H110NAS1
TECHNICAL BULLETIN
 01 MAY 2018

Service Action: A-Pillar Water Ingress

MODEL:	MODEL YEAR:	VIN:	ASSEMBLY PLANT:
XE (X760)	2017-2018	P10648-P17693	Castle Bromwich

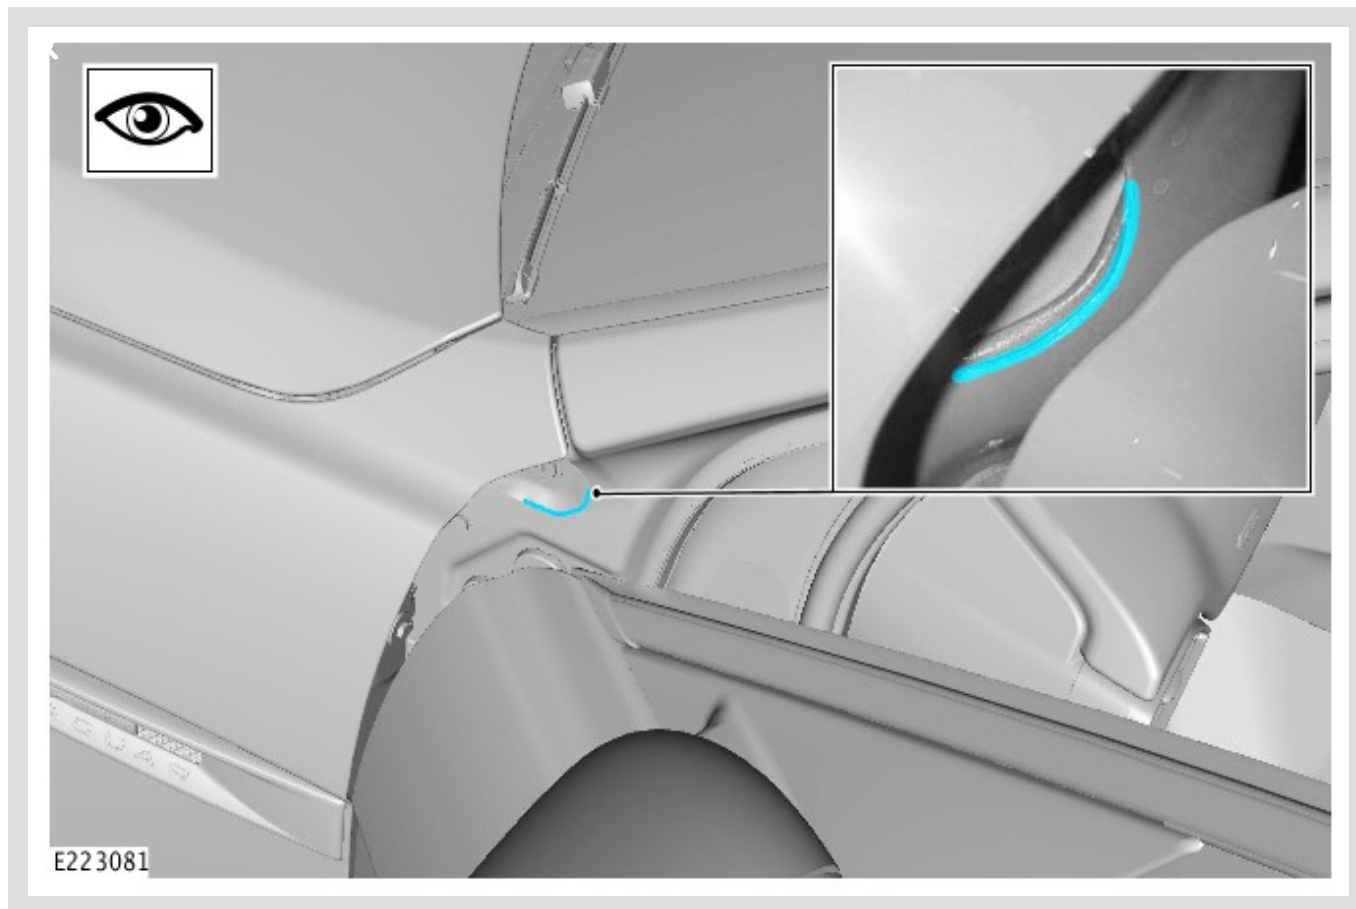
An issue has been identified on certain vehicles within the listed Affected Vehicle Range where due to a change to the robotic sealing process, a small area of sealant at the left and right A-pillar was omitted. As a result of this, water can run through this area into the passenger compartment of the vehicle.

Left A-pillar area shown; right A-pillar area similar.

Area in which water can enter the passenger compartment.
